URBAN DESIGN REVIEW PANEL REPORT

Project:	2514 – 441 Echo Drive	Date:	07 May 2026
Hearing Date:	06 March 2026, 10:30am	Pages:	126
Comments Received:	17 March 2026		
File No.	PC2025-0290

RESPONSE TO UDRP RECOMMENDATIONS

441 ECHO DRIVE SITE PLAN

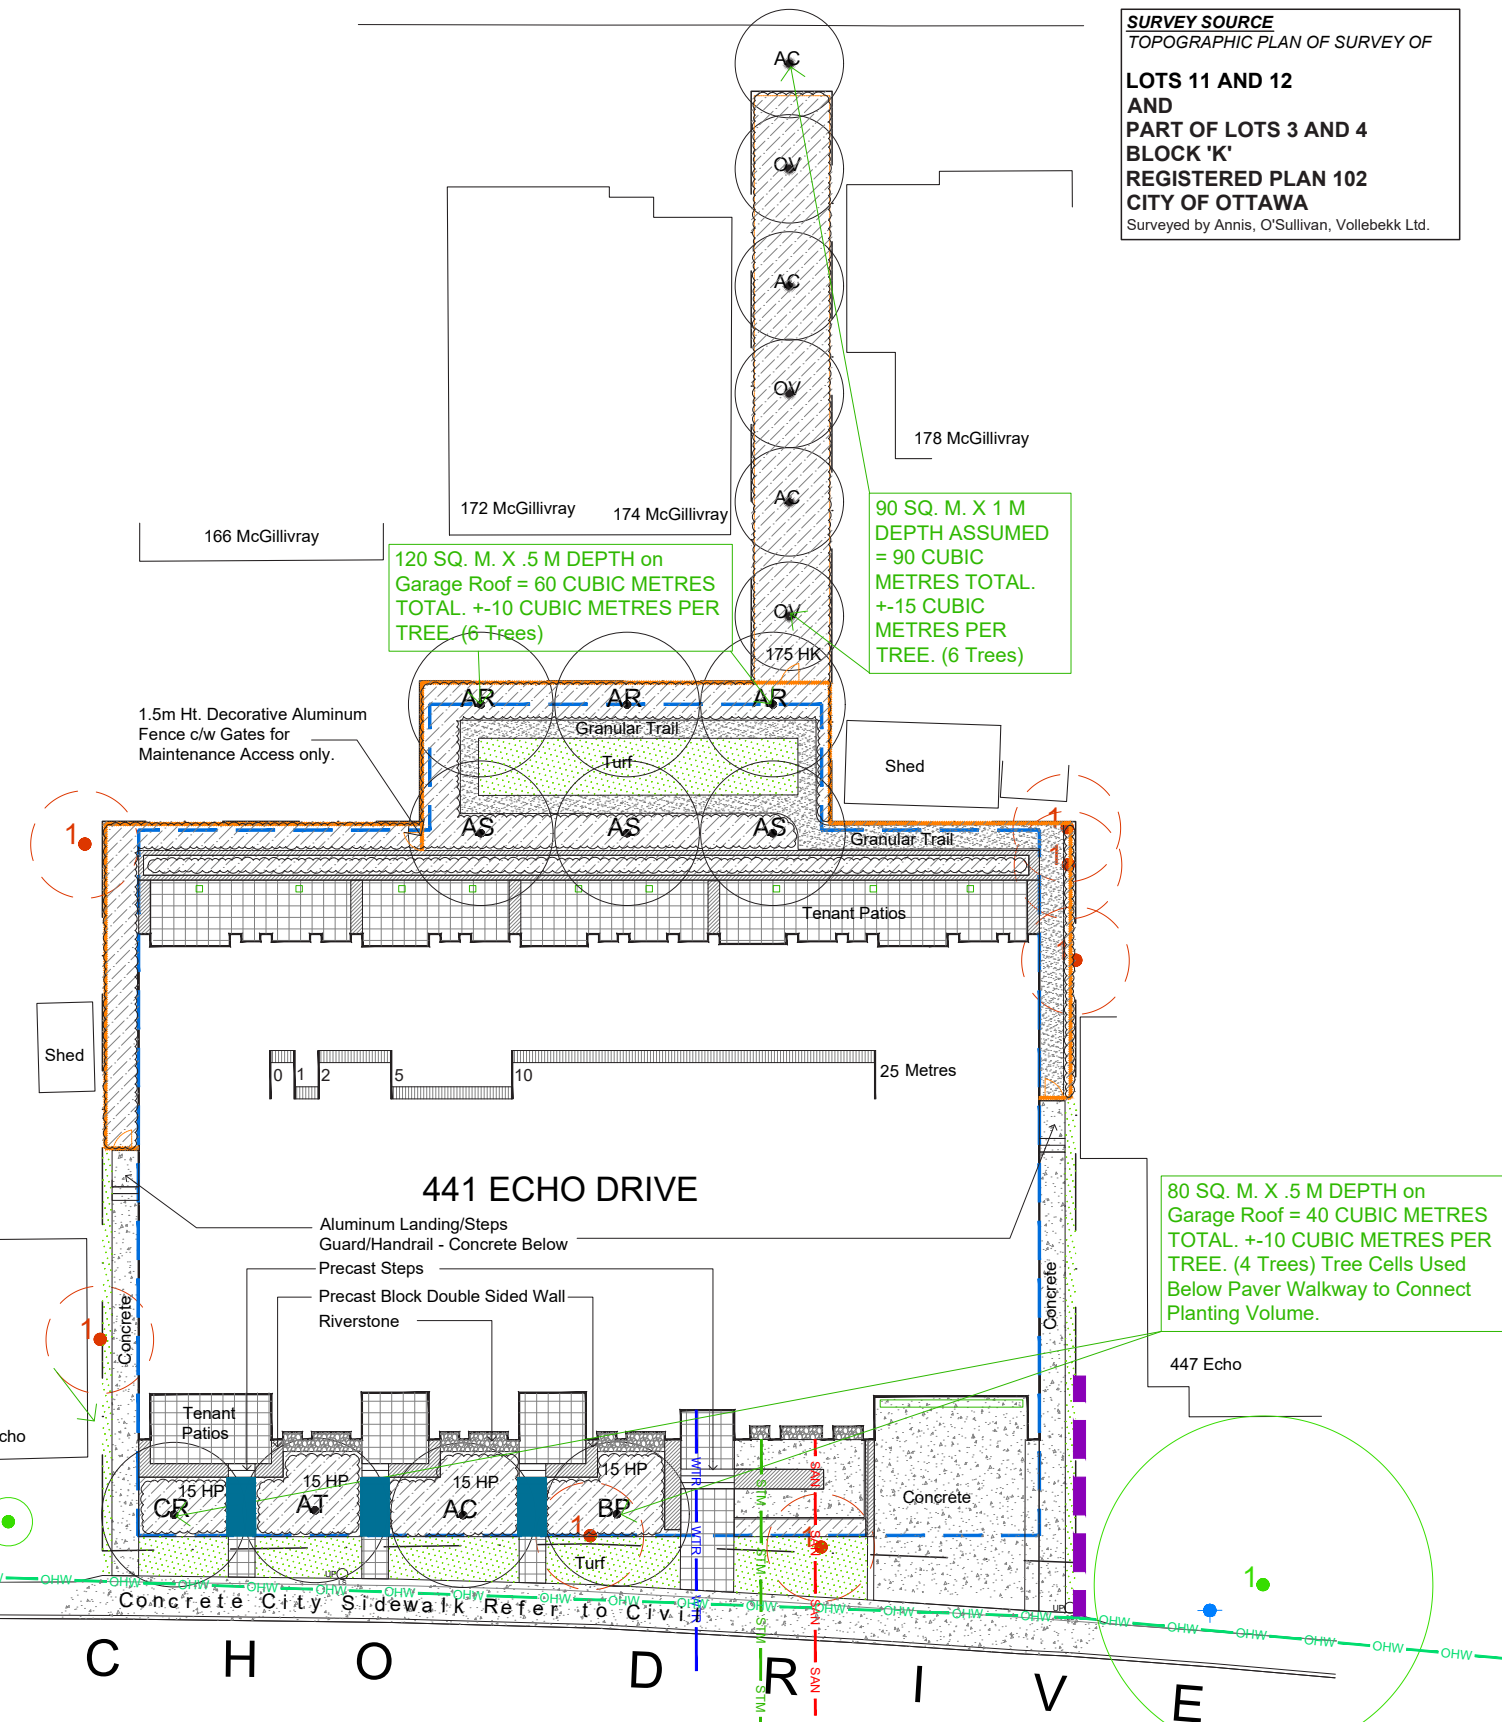
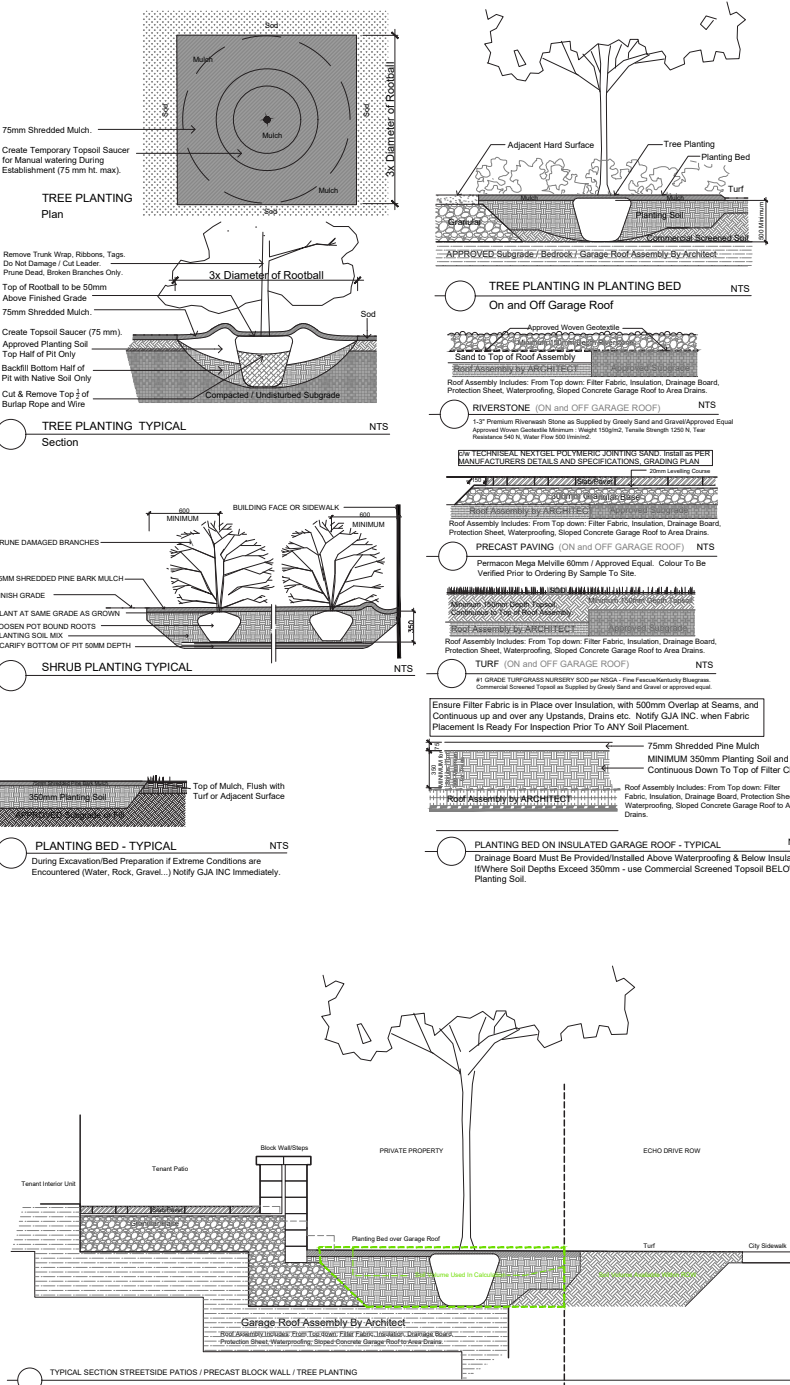
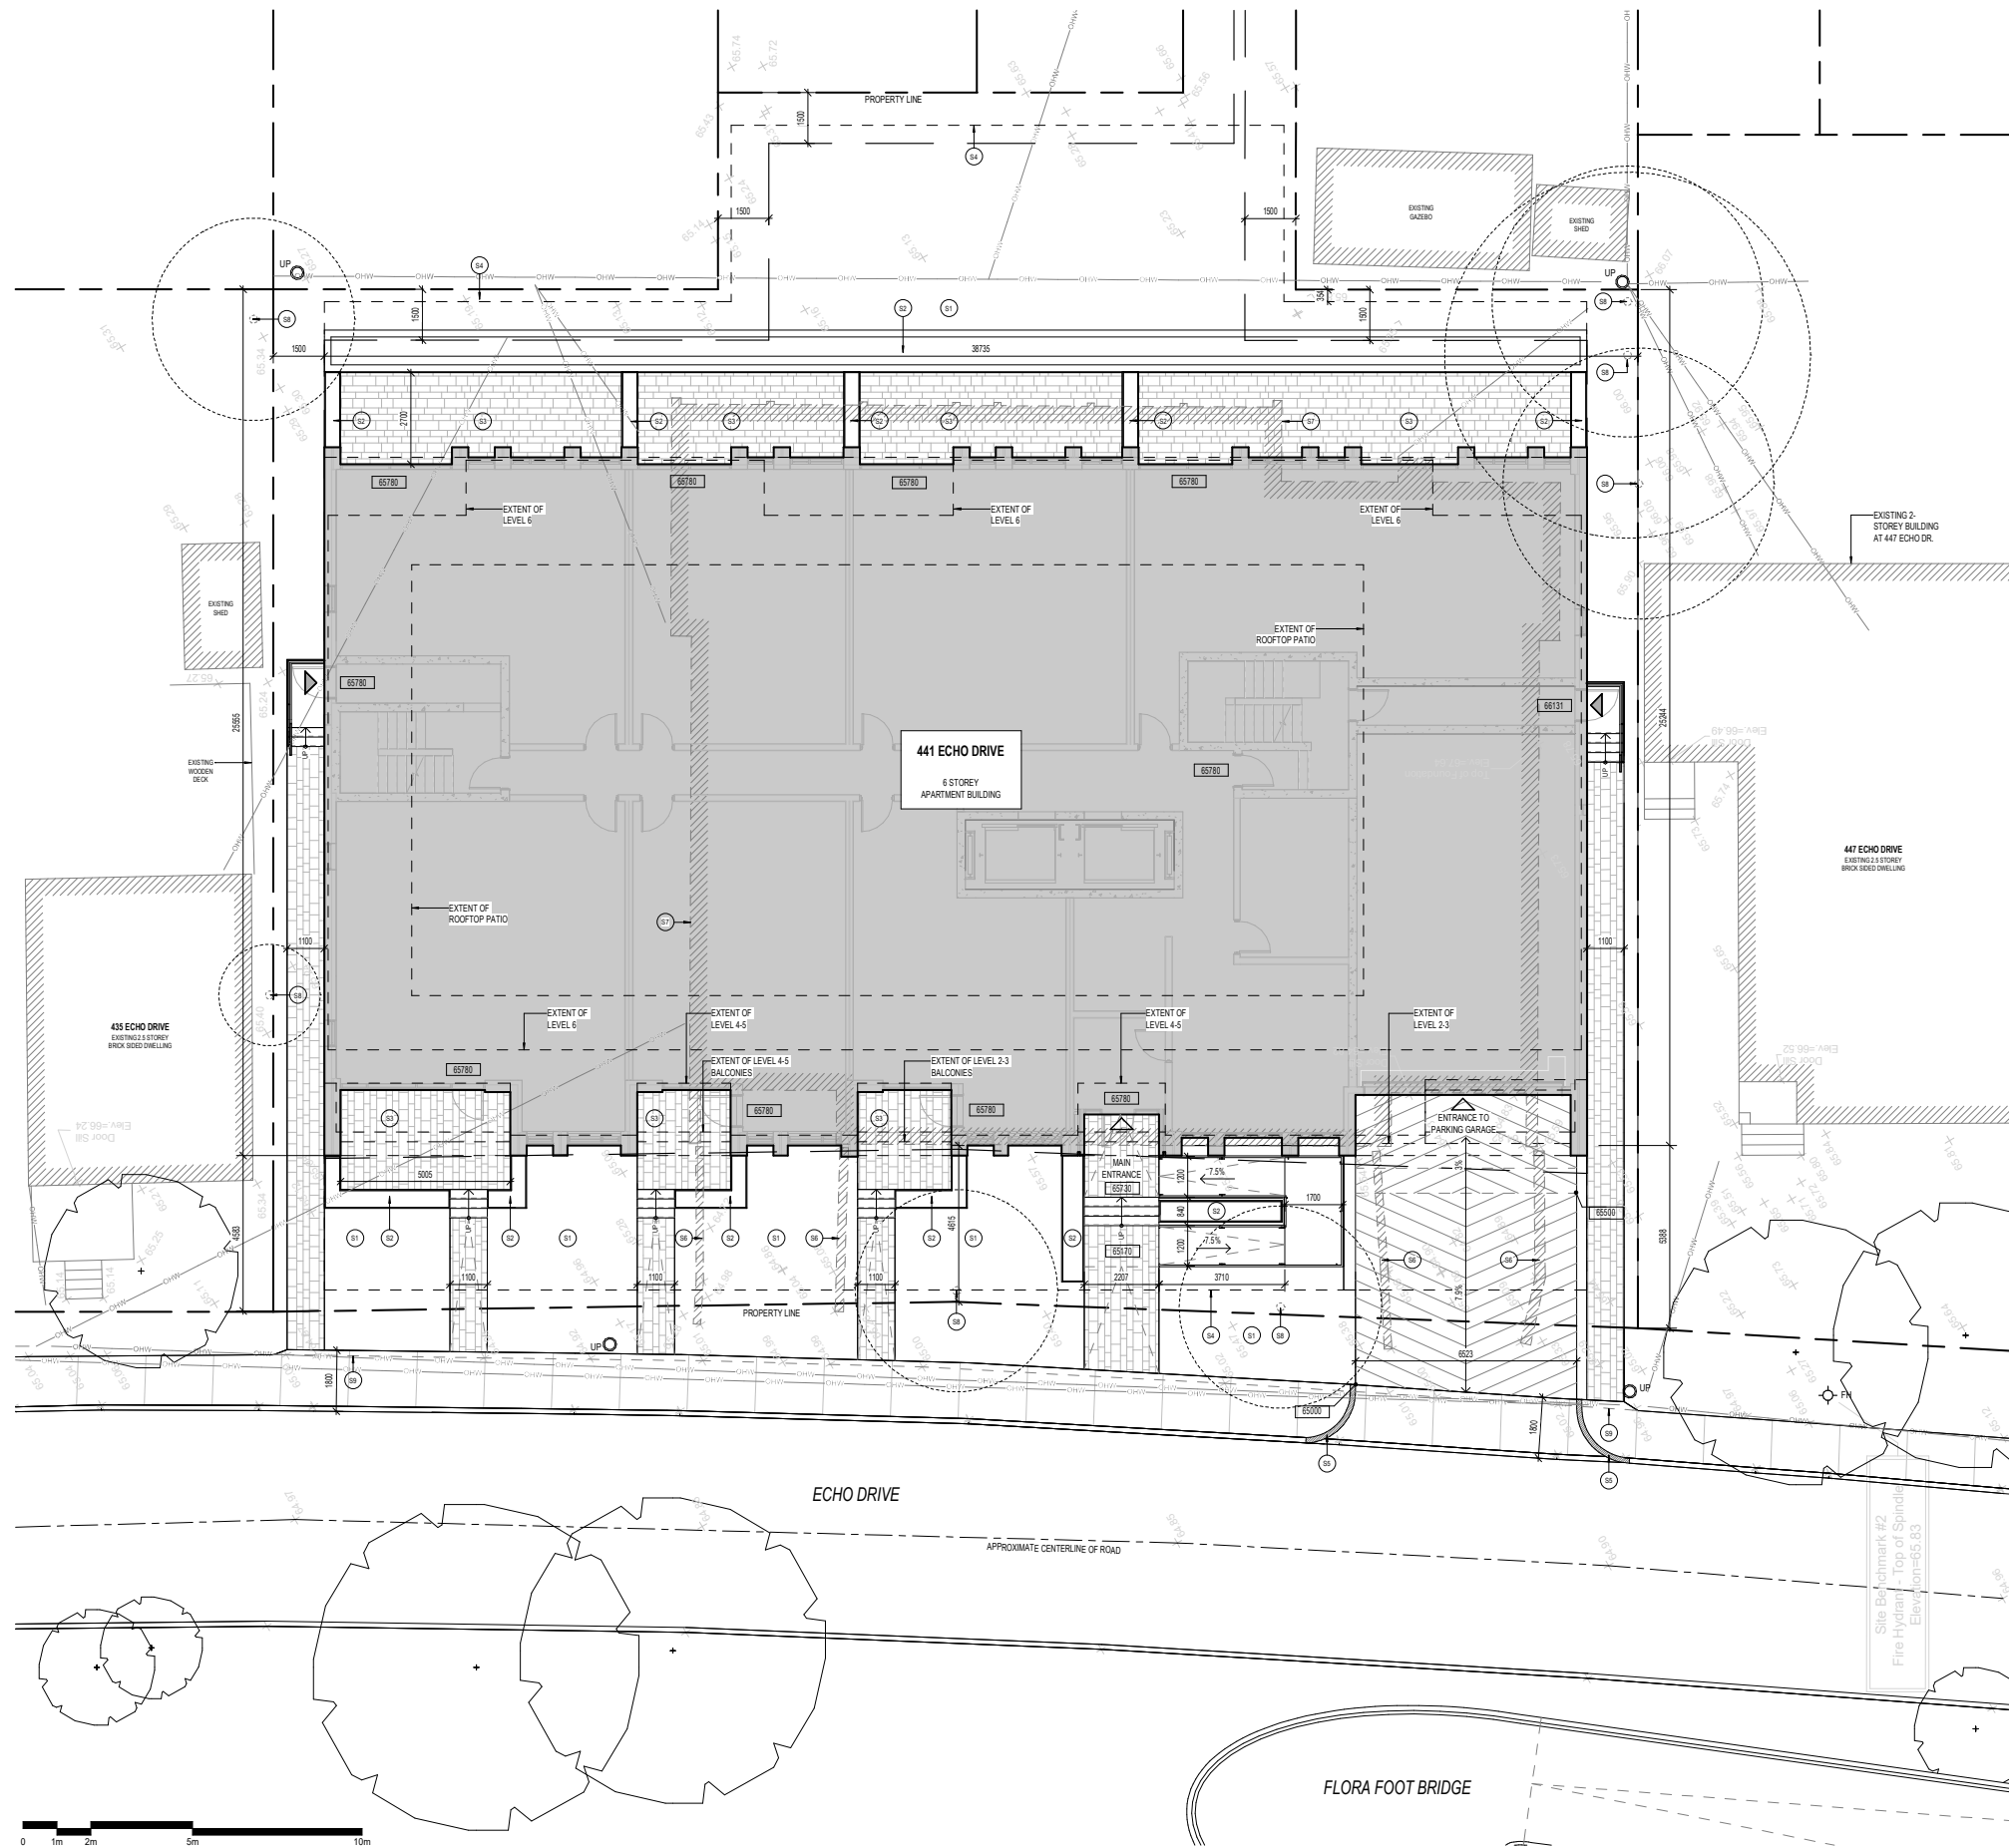
The Panel suggests reviewing the site design to ensure that proposed trees have access to adequate soil volumes. Where possible, trees should not be planted on structural slabs, as this can limit their long-term health and growth.

The Panel also noted opportunities to refine the landscape programming within the site. The rear yard currently appears largely planted, and the Panel encourages introducing small, shared amenity spaces for residents, such as seating areas, gathering spaces, or community gardening plots.

This comment is noted, however with the required grading for the site providing barrier-free access to this area is challenging. That said, we will continue to explore opportunities to program this area but this may be more as private amenity space instead of a communal amenity area.

West Elevation

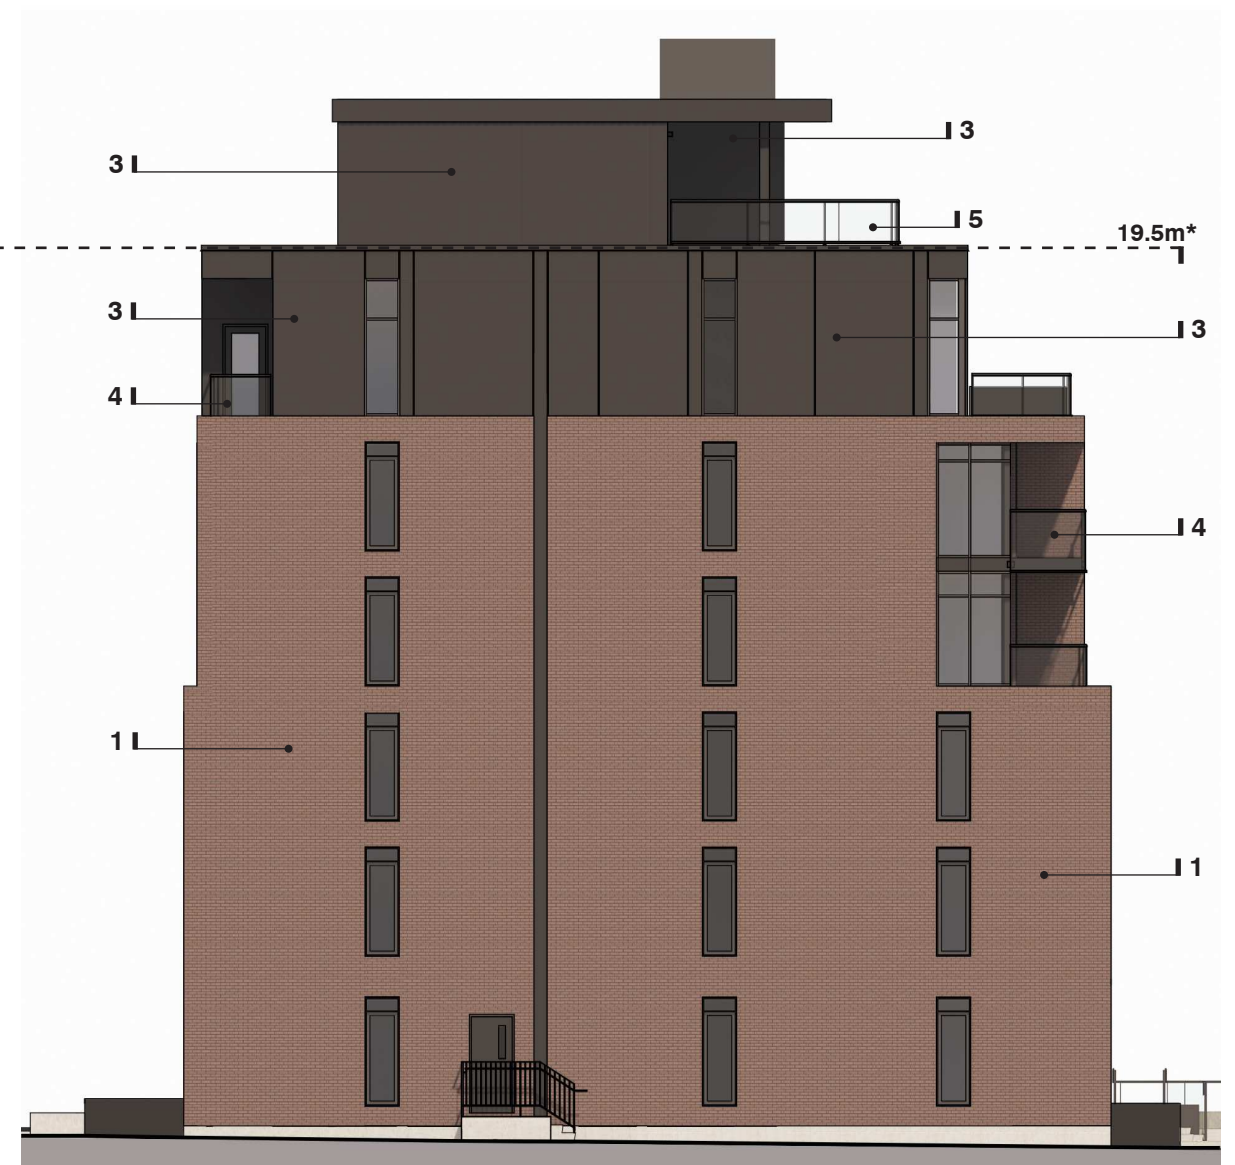
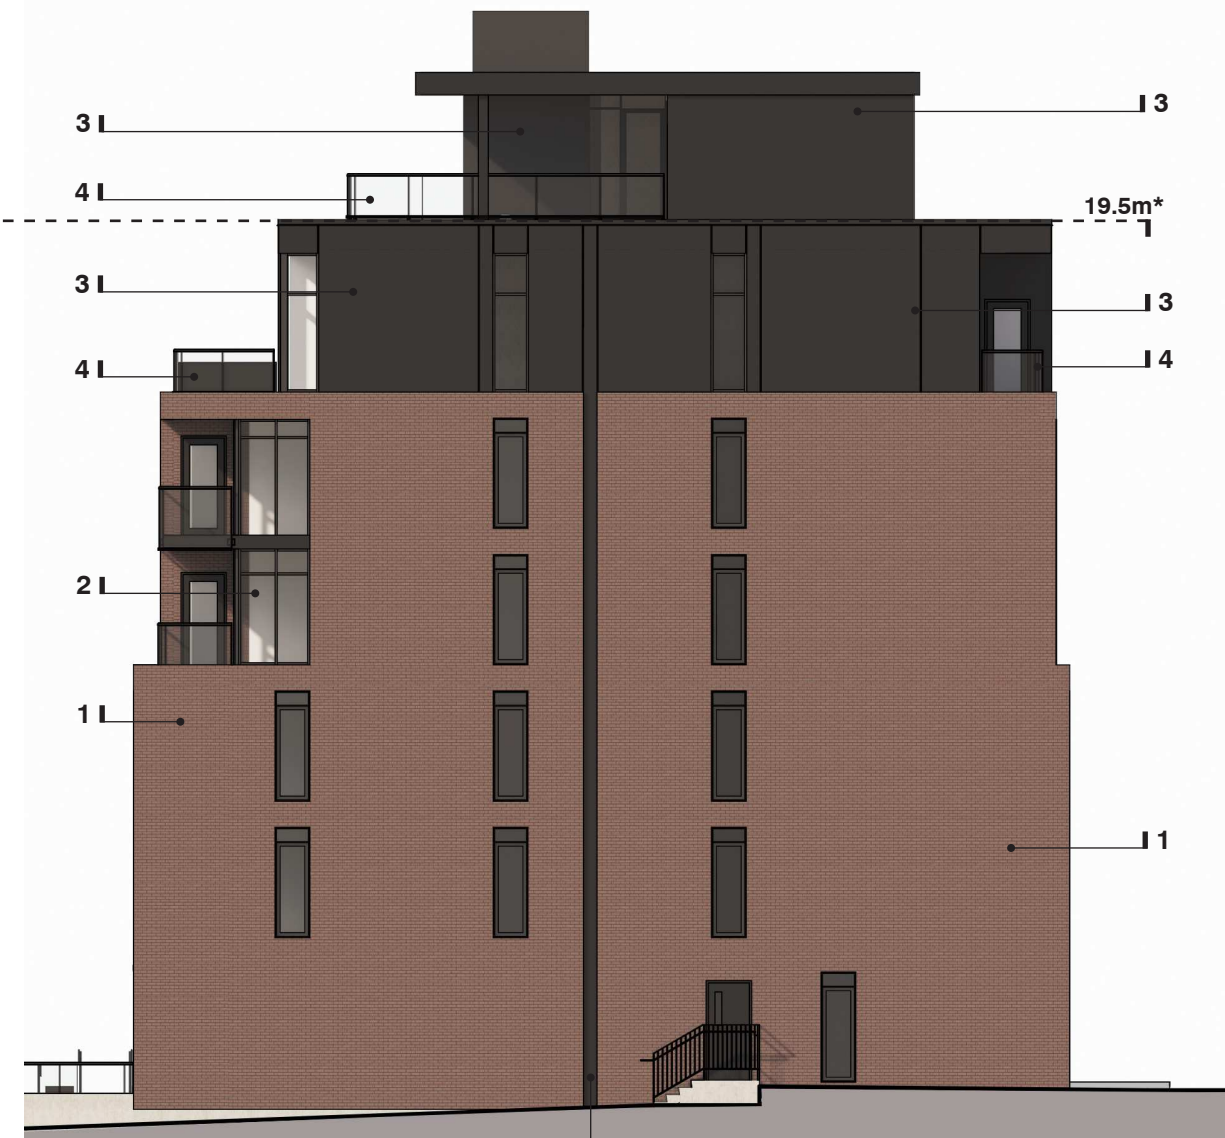
- *The Panel expresses concern relates to the side yard setbacks, particularly along the north side and south sides above the 5th floor. The Panel recommends introducing greater setbacks on the top floors along the side of the building to reduce the perceived mass and address the proximity to adjacent buildings.*
 It is not feasible for the project to step in along the interior side yard at Level 06, however we have provided a significant step back of the building at Level 07 which is visible in the revised rendering package. We feel that this change is a fair balance between reducing the impact of the built form and maintaining the performance requirements of the project.

It is not feasible for the project to step in along the interior side yard at Level 06, however we have provided a significant step back of the building at Level 07 which is visible in the revised rendering package. We feel that this change is a fair balance between reducing the impact of the built form and maintaining the performance requirements of the project.

With respect to mitigating the scale of the building in the pedestrian realm, the building offers step backs on Level 04, Level 06 and Level 07 (Roof Level) on the west elevation. We disagree that there is a need to step the building back from the interior side yards as this transition would have relatively little impact on the street. We also question why stepping back on the north side is of more importance than the south side. There are plenty of zones in the city that permit 6 stories, and the step back requirements for these buildings are only on the front yard side, not the interior side yards.
